HOWARD COUNTY
 PERMIT APPLICATION

B-300-646

Existing Use Single Family
 Proposed Use Single Family
 Estimated Construction Cost \$ 2,000
 Description of Work Ceil the living room
instead of 2-story ceiling
Due to access Southern Exposure +
Heat Collecting that kind of floor

SEIBERT PROPERTY LOT 2
 MAP 22 G-19 PARCEL 327
 4211 Lanthicum Rd Dayton, Md

Approved Septic System Plan
 Howard County Health Department

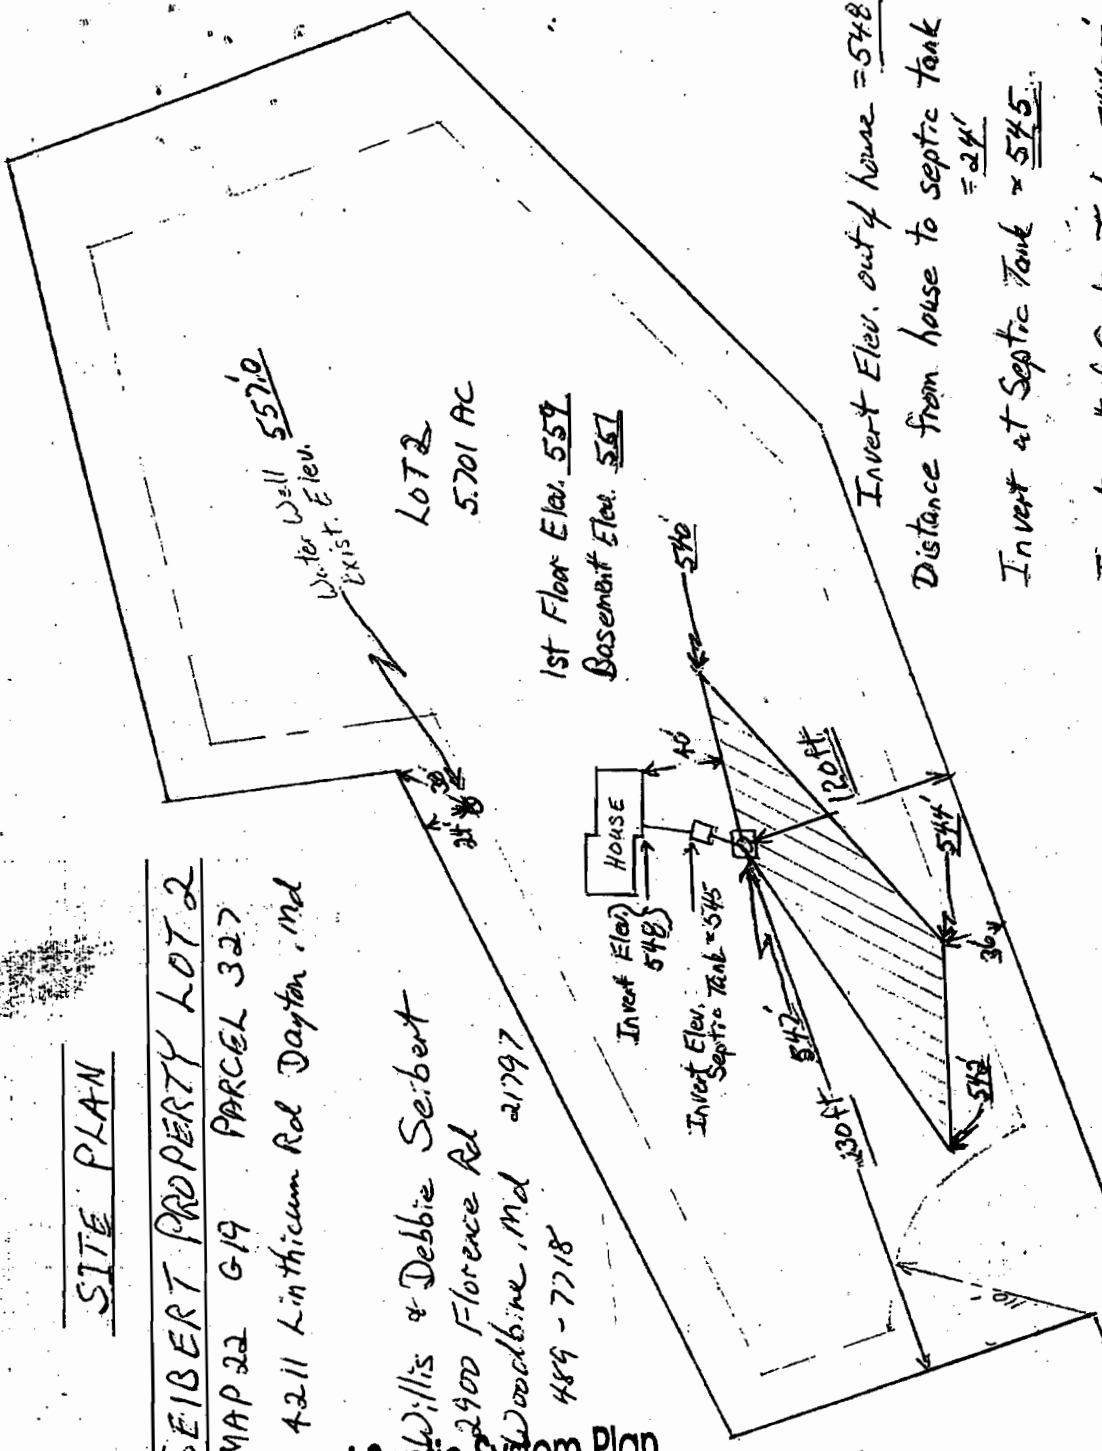
Close-in ceiling/flooring between 1st & 2^d Floors
 Septic system existing has design capacity for 5 Bed room, per 1/107 Cde.
